October 27, 2006

**Re: Housatonic River - West Branch (Site Number GESD02)
Addendum to Second Supplemental Sampling Summary Report and Remedial Action
Proposal for the West Branch of the Housatonic River**

FIGURE
1

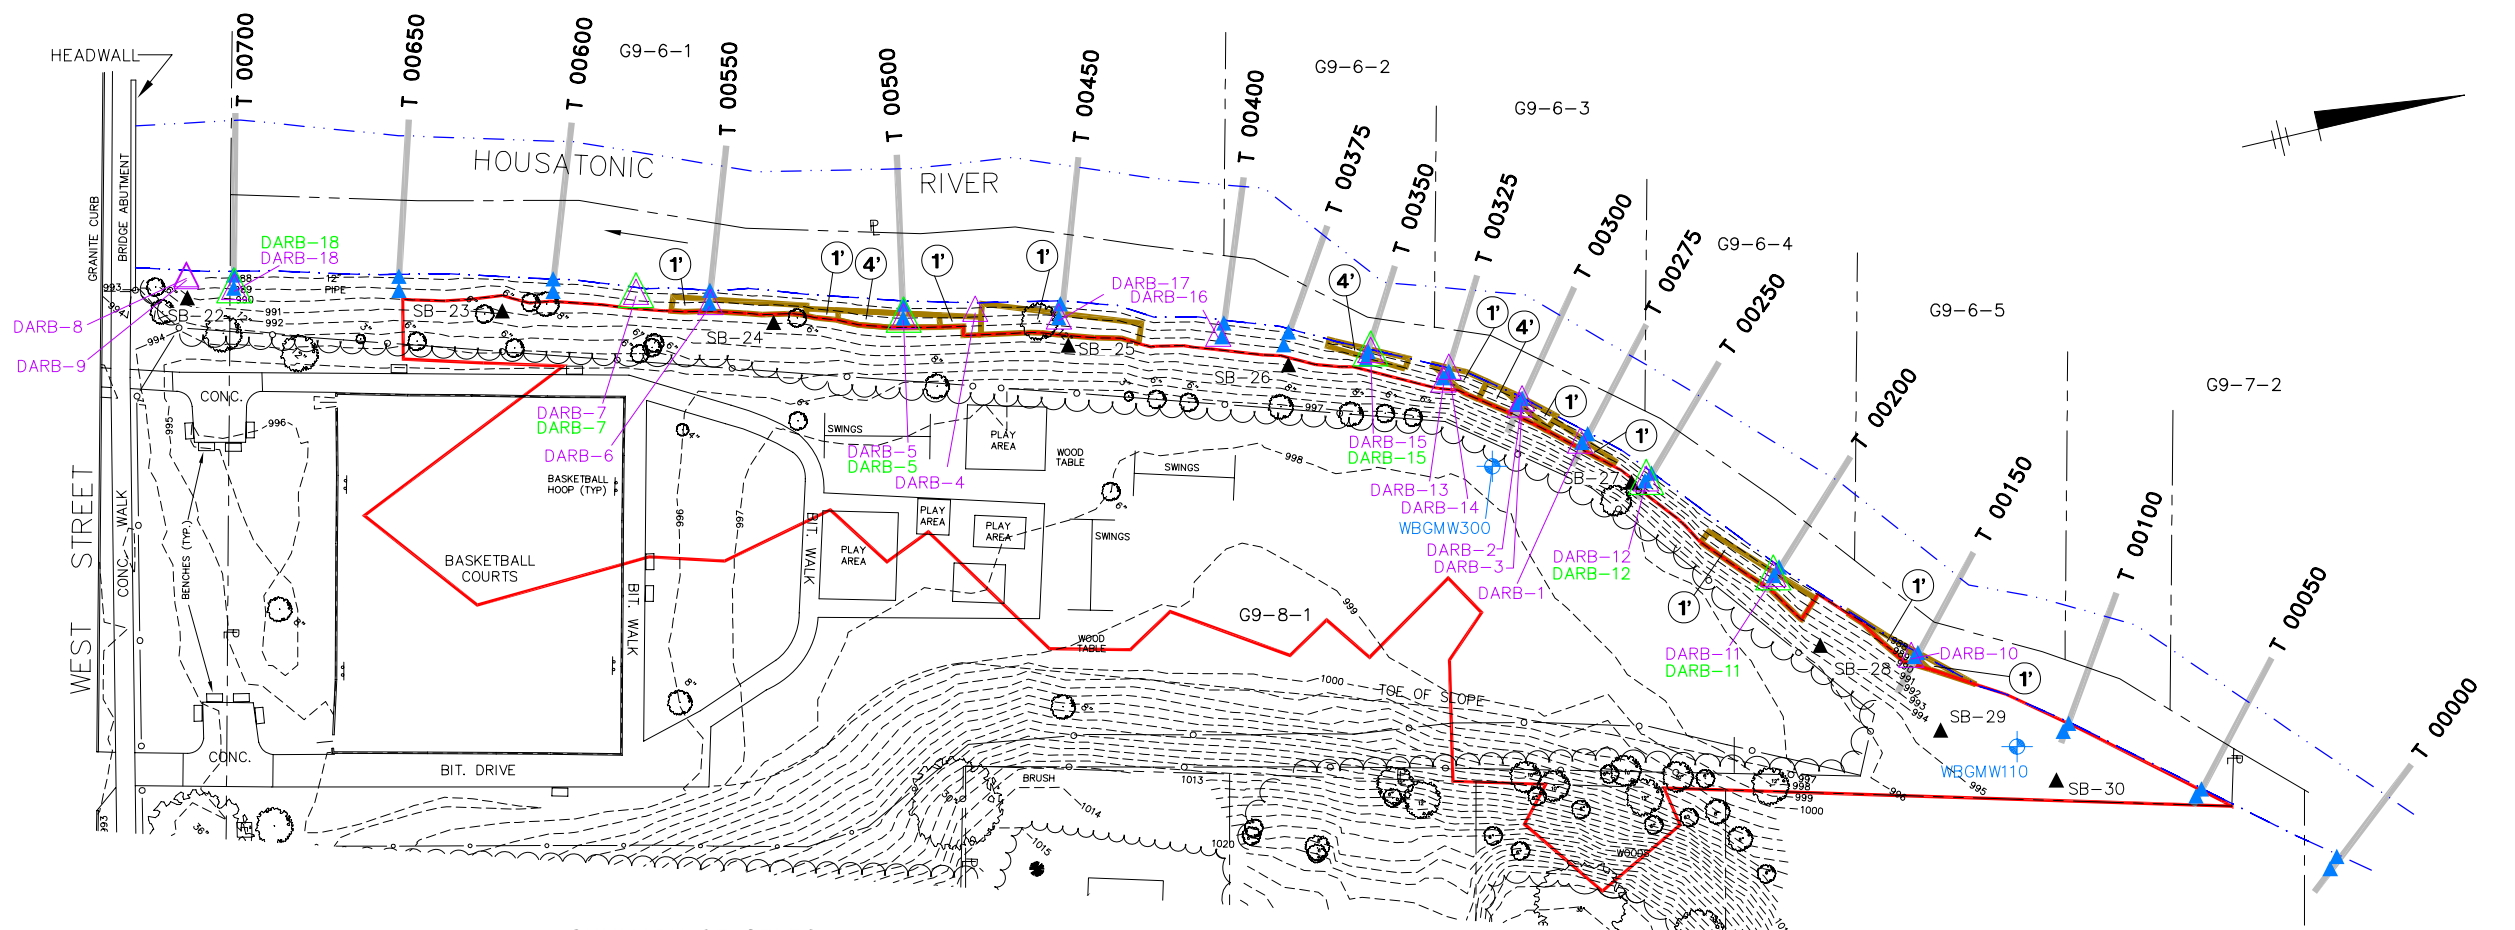
MDEP Condition No. 1 – *In Section 3 of the Report, GE proposes to remove soils, as necessary, to achieve a spatial average PCB concentration of 10 parts per million (ppm) in both the top foot and in the top 3 feet of the bank. The proposed remediation standard of 10 ppm is based on the assumption that the riverbanks can be considered to be recreational in use, with no foreseeable use for residential purposes due to their proximity to the river and steep slope. Under the Massachusetts Contingency Plan (MCP), if the average concentration of PCBs does not meet the Method 1 Soil Standard of 2 ppm, then a Notice of Activity and Use Limitation (AUL) must be implemented to restrict activities and uses at the site to those for which the cleanup levels are protective.*

MDEP Condition No. 4 – *In the Report, GE did not propose sampling of riverbank soils and river sediments for the [Appendix IX+3] constituents GE shall include a proposal for Appendix IX+3 sampling of soils and sediments in the Addendum to the Report. The sampling proposal shall address riverbank soils from transect T00100 to the West Street bridge and sediments from transect T00300 to the West Street bridge. However, if option #2 under comment 3 (above) is selected, no Appendix IX+3 sampling will be required for the sediments.*

In addition to the soil removals to achieve the above standards, GE proposed in the Second Supplemental Report to perform some additional removal to address elevated PCB concentrations at three locations in the 3- to 4-foot depth increment (i.e., DARB-2, DARB-5, and DARB-15). GE further explained that soil removal limits for these three sample locations were developed by extending the 2- to 3-foot depth removal polygons in these areas down to 4 feet. However, the soil removal limits associated with the 3- to 4-foot depth increment at sample location DARB-5 were inadvertently developed using the polygon for the 0- to 0.5-foot depth increment instead of the polygon for the 2- to 3-foot depth increment (which is slightly smaller). GE has revised the soil removal limits at this location to be based on a downward extension of the 2- to 3-foot depth removal polygon.

This modification has resulted in a slight change in the estimated soil removal volume associated with this remediation – from approximately 100 cubic yards (as stated in the Second Supplemental Report) to approximately 85 cubic yards. The revised soil removal limits are presented on Figure 1. As shown above, those limits will result in achievement of the recreational standards for the 0- to 1-foot and 1- to 3-foot depth increments. In addition, as it did in the Second Supplemental Report, GE has calculated the post-remediation spatial average concentration for the overall depth increment that extends to the depth of detection of PCBs on these riverbanks – 6 feet. As shown in Table A-5 in Attachment A, that post-remediation average is 4.9 ppm, which is less than both the MCP Upper Concentration Limit (UCL) of 100 ppm for PCBs and the recreational soil remediation standard of 10 ppm for the top foot.

GE Response – Since GE has elected to implement MDEP's option 2 for sediment remediation, its proposal for sampling for non-PCB Appendix IX+3 constituents is limited to the lower riverbank soils. GE proposes to collect soil samples from six riverbank locations for Appendix IX+3 analyses. In selecting the locations and depths for these samples, GE has reviewed the PCB-related soil removal limits in an effort to collect the Appendix IX+3 samples from soils that could potentially remain in place after the PCB remediation. Thus, the locations and depths selected are all ones that would remain after the PCB remediation to achieve recreational standards, although a few of those sample locations would be removed by a PCB remediation to achieve the Method 1 soil standard. Specifically, GE proposes to collect soil samples for Appendix IX+3 analyses at the following locations and depth increments, as shown on Figures 1 and 2:

- DARB-12 (0-1')
- DARB-18 (0-1')
- DARB-7 (1-3')
- DARB-11 (1-3')
- DARB-5 (4-6')
- DARB-15 (4-6')

FIGURE
2

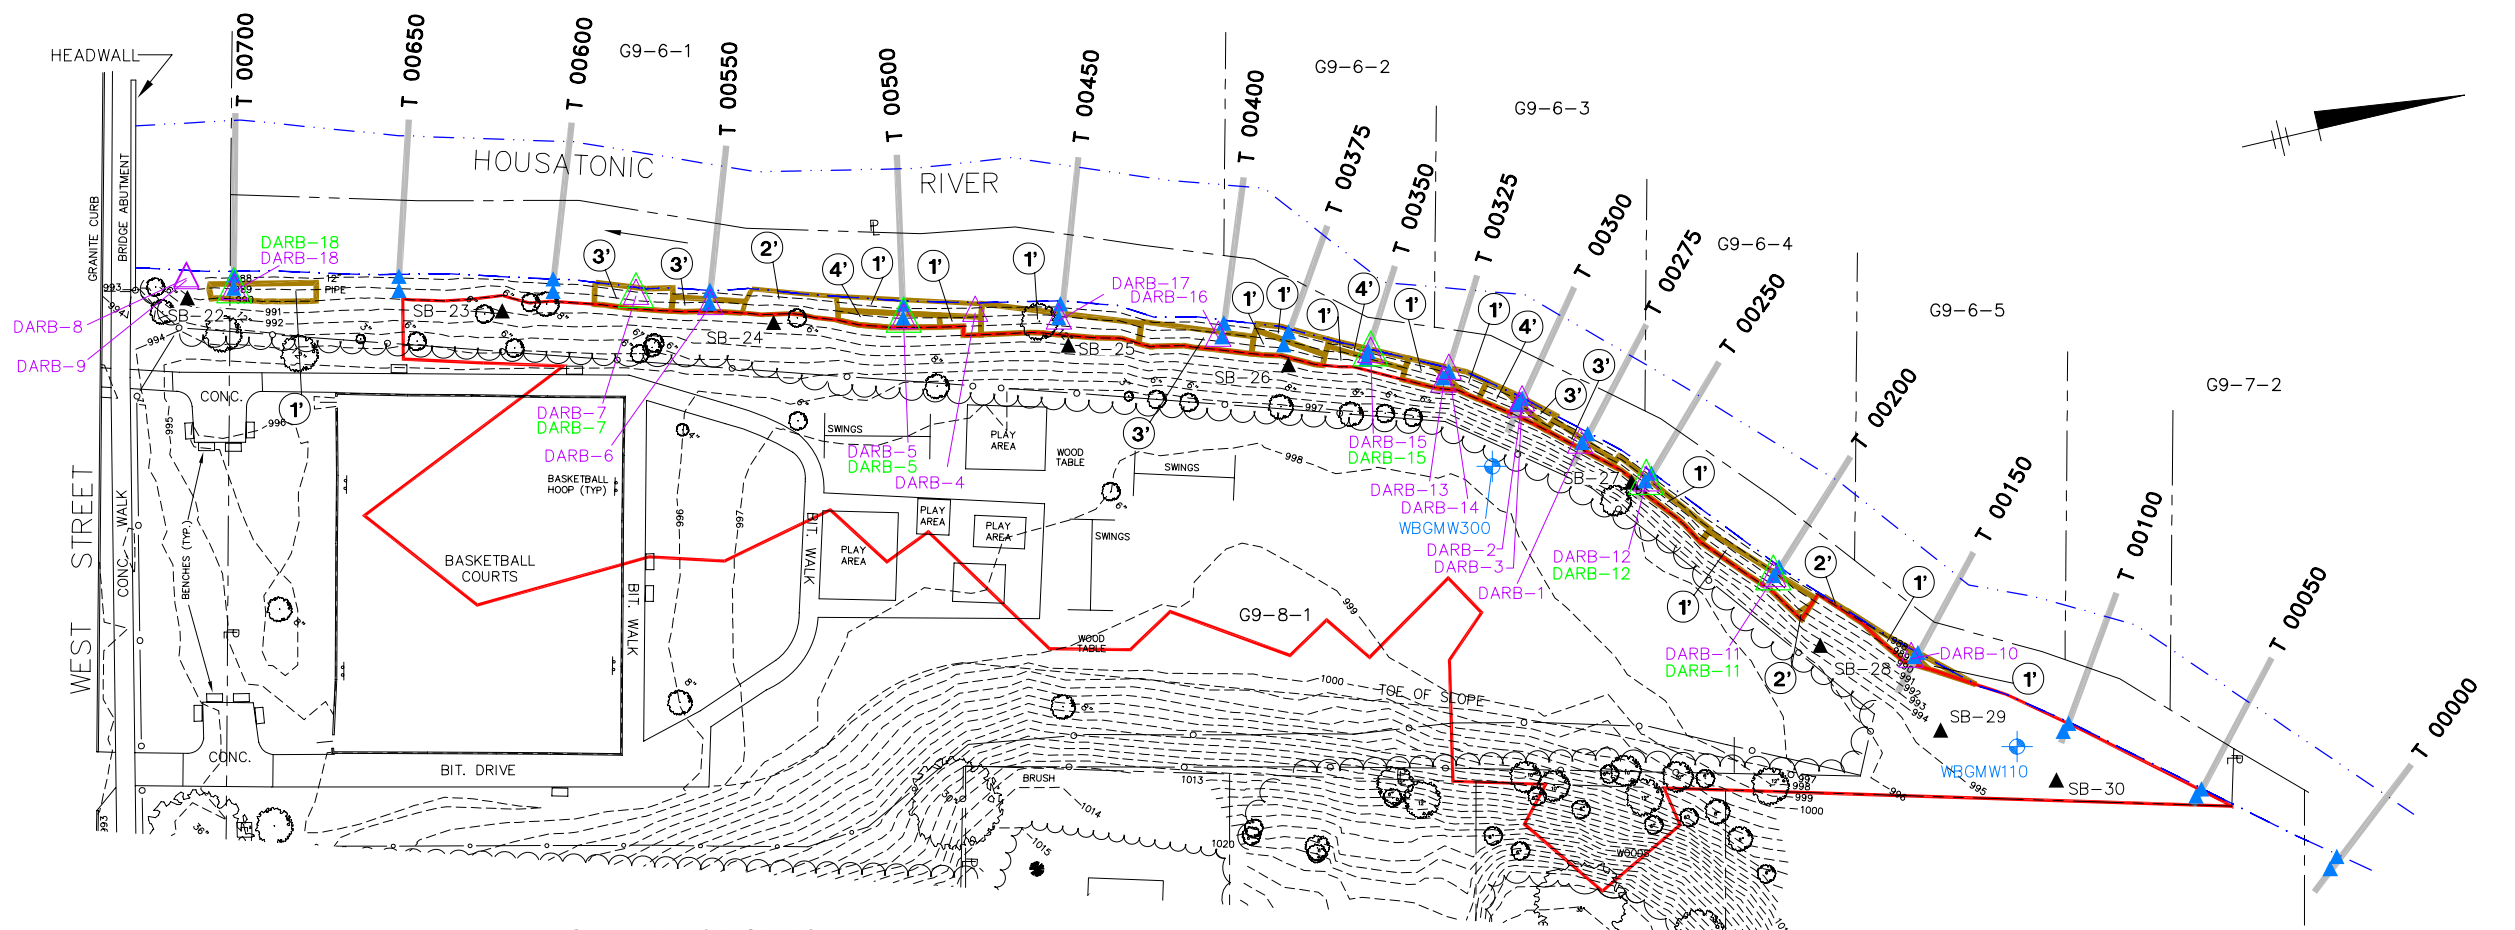
In the event that an AUL is not obtained for the lower riverbanks, GE will remediate the lower riverbank soils to achieve the MCP Method 1 soil standard of 2 ppm for PCBs. To determine the soil removal limits necessary to achieve that standard, GE has evaluated the depth increments used to assess residential properties – i.e., the 0- to 1-foot depth increment and the greater than 1 foot depth increment (to the depth at which PCBs have been detected). In this case, since PCBs have been detected on the lower riverbanks to a depth of 6 feet, the depth increments subject to evaluation are the 0- to 1-foot and 1- to 6-foot depth increments. The PCB evaluations and polygon mapping for the lower riverbank soils under this remediation scenario are presented in Attachment B and summarized below.

As shown above, the existing average PCB concentration for the 0- to 1-foot depth increment (~ 144 ppm) is above the MCP Method 1 soil standard of 2 ppm. Further, as shown in Table B-2 in Attachment B, the existing average PCB concentration for the 1- to 6-foot depth increment is 57.1 ppm, which is also greater than the Method 1 standard. GE has developed a scope of soil removal and replacement to achieve the Method 1 soil standard of 2 ppm in both of these depth increments on the lower riverbanks. The soil removal limits proposed to achieve this standard are shown on Figure 2 and would involve the removal of approximately 185 cubic yards of riverbank soil. The evaluations in Attachment B indicate that soil removal to those limits would result in achievement of the Method 1 soil standard, as shown in the following table.

PROPOSED SEDIMENT
 REMOVAL LIMITS

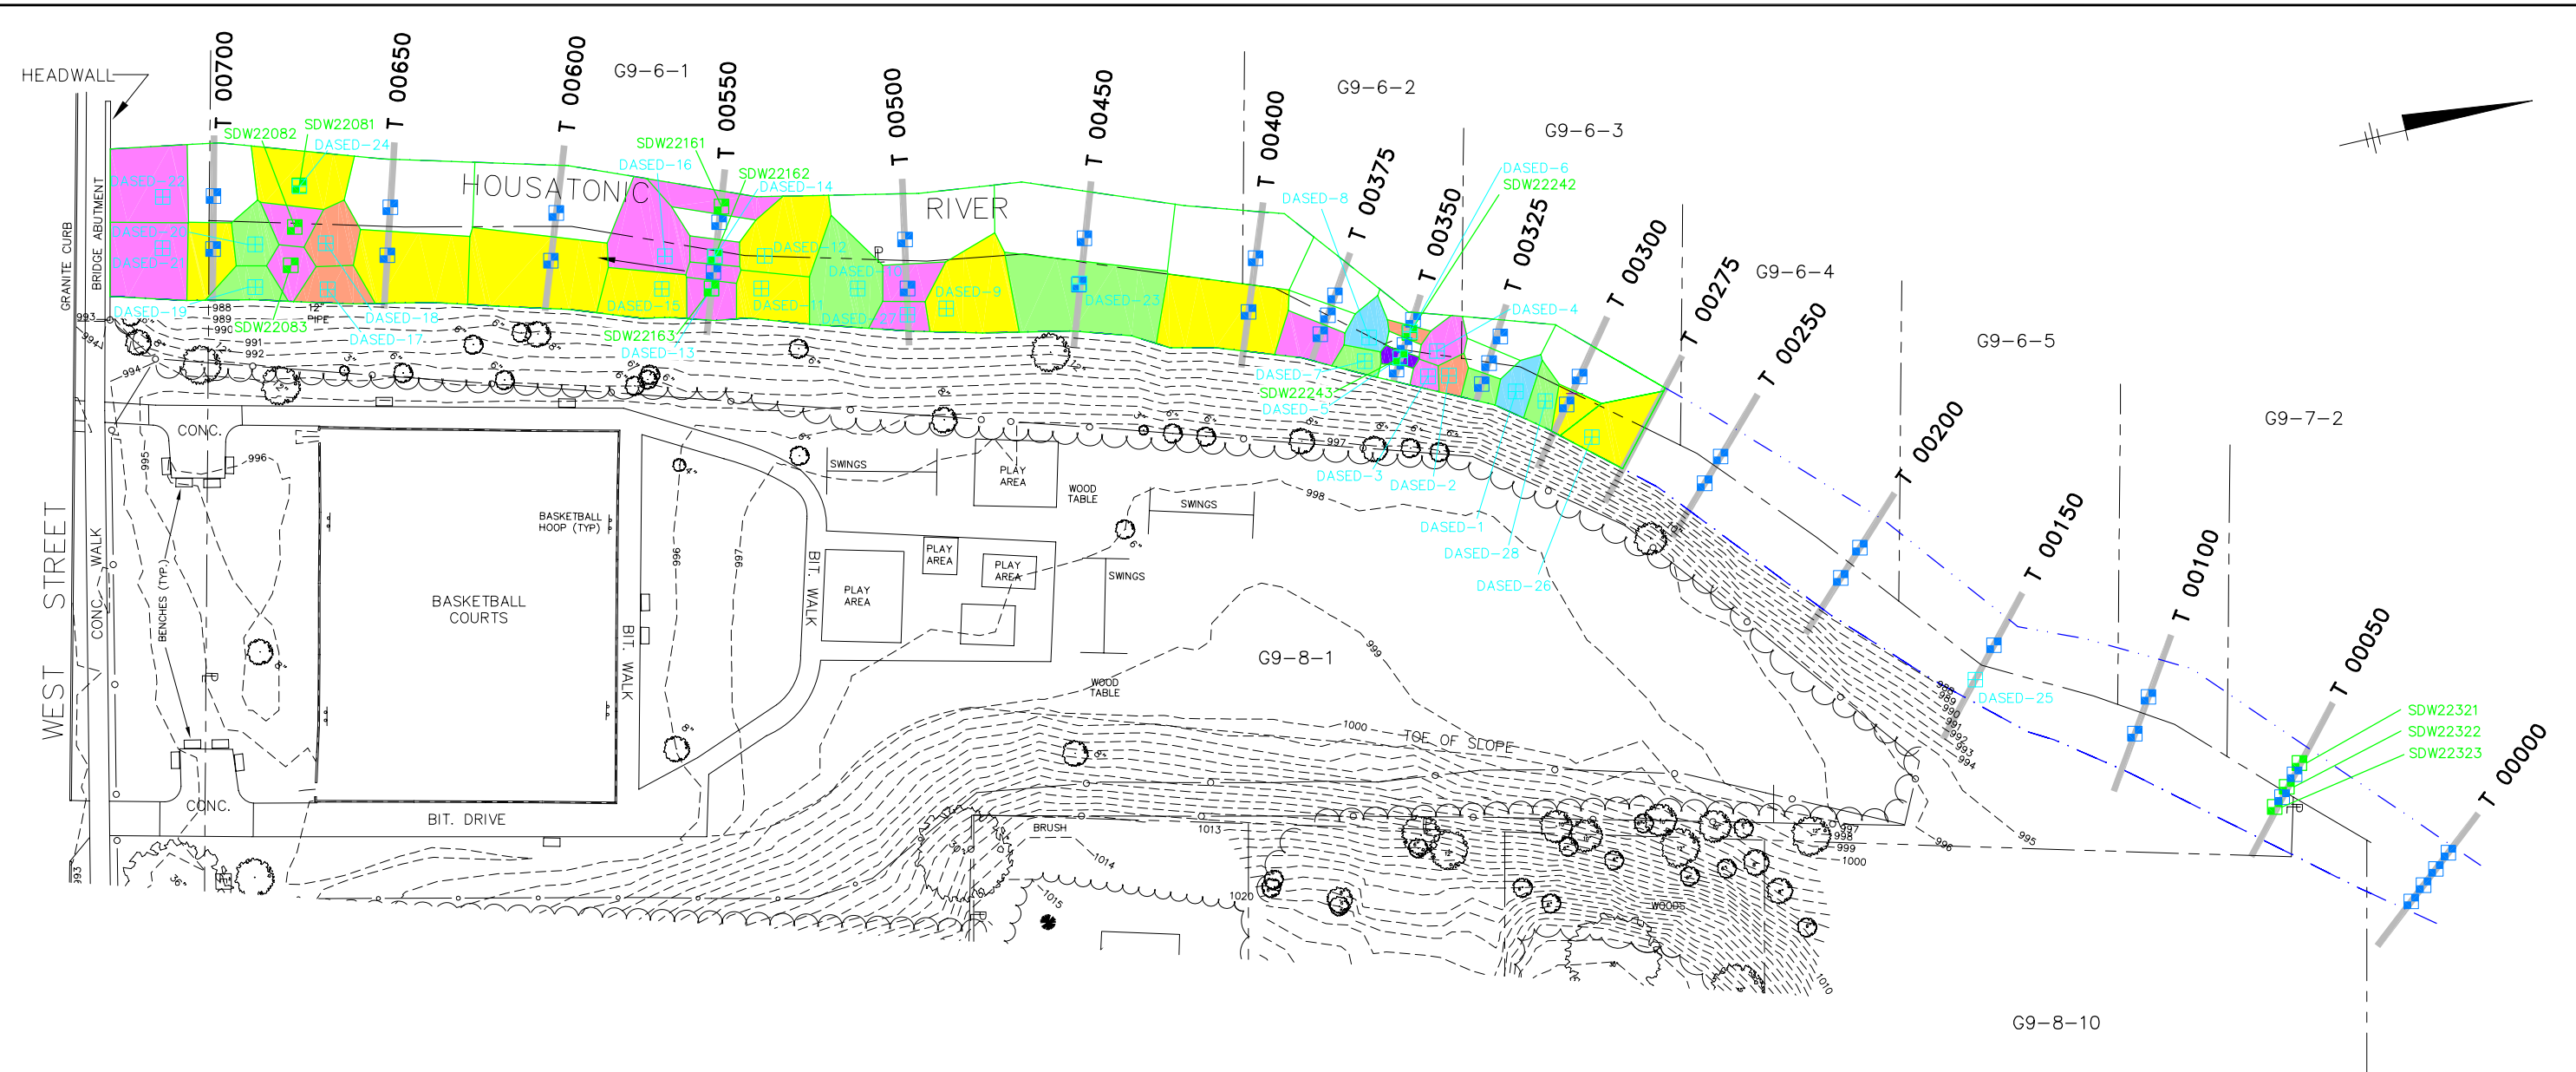
MDEP Condition No. 3 – *In Section 3.2 of the Report, GE states that it has not identified any a priori remediation standard for sediments. Instead, GE proposes to remove sediments to achieve an arithmetic average of 0.40 ppm in the top foot and 0.36 in the 0- to 3-foot depth increment. Under the MCP, a Method 3 Risk Characterization to evaluate the risk of harm to health, safety, public welfare, and the environment is required at disposal sites unless response actions have successfully reduced contaminant concentrations to background levels, as described in 310 CMR 40.0999. GE does not provide such a Risk Characterization in the Report. GE shall use one of the following three options to demonstrate that post-remediation PCB sediment concentrations will achieve a condition of No Significant Risk:*

- *Perform a Method 3 Risk Characterization to support the proposed post-remediation concentrations;*
- *Remove all PCB-contaminated sediment represented by detectable concentrations of PCBs from transect T00300 to the West Street bridge; or*
- *Remove sediments to achieve the average PCB concentrations proposed in the Report, and perform fish tissue sampling as recommended by the Department's Office of Research and Standards in a memorandum to Anna Symington dated July 24, 2006 with subject "Review of the Second Supplemental Sampling Summary Report and Remedial Action Proposal for the West Branch of the Housatonic River, Prepared by BBL, Inc., for the General Electric Company, April 2006"*

GE shall present either a Method 3 Risk Characterization, a plan to remove all contaminated sediments adjacent to the Park, or a plan to perform fish tissue sampling in the West Branch in the Addendum to the Report.

GE Response – GE continues to believe that the sediment remediation approach proposed in the Second Supplemental Report is fully protective, as well as consistent with the approach used in the Consent Decree (and agreed to by MDEP) for the Upper ½ Mile Reach of the East Branch of the Housatonic River. Nevertheless, to comply with MDEP's directive, GE has elected to implement the second bulleted option listed by MDEP – removal of all detectable concentrations of PCBs in the identified river stretch – despite the fact that this represents an overly conservative approach to sediment removal within the West Branch.

To determine the extent of removal to achieve this option, a review of the sediment sampling data was performed to identify sampling locations where detectable concentrations of PCBs were reported. Further, to assist in developing of the limits of sediment removal, a Theissen polygon map was created utilizing all available sediment sampling locations between Transect 00300 and the West Street Bridge.

The horizontal limits of soil removal were then determined by identifying each sediment sampling location and the corresponding polygon at which detectable concentrations of PCBs were reported. To determine the vertical extent of removal within each polygon, the sampling data were evaluated to determine the depth at which PCBs were not detected. The resulting limits of sediment removal and the sediment sample data are presented on Figure 3. Although MDEP's conditional approval letter only specified the removal of detectable PCB concentrations between Transect 00300 and the West Street Bridge, GE has extended the removal to address a detected PCB concentration just to the north (upriver) of Transect 00300 at sampling location DASED-26. Under this scenario, the total estimated volume of sediment removal is approximately 900 cubic yards. These sediment removal limits are preliminary; they will be further reviewed during development of the forthcoming RAWP and may be modified to incorporate constructability considerations.
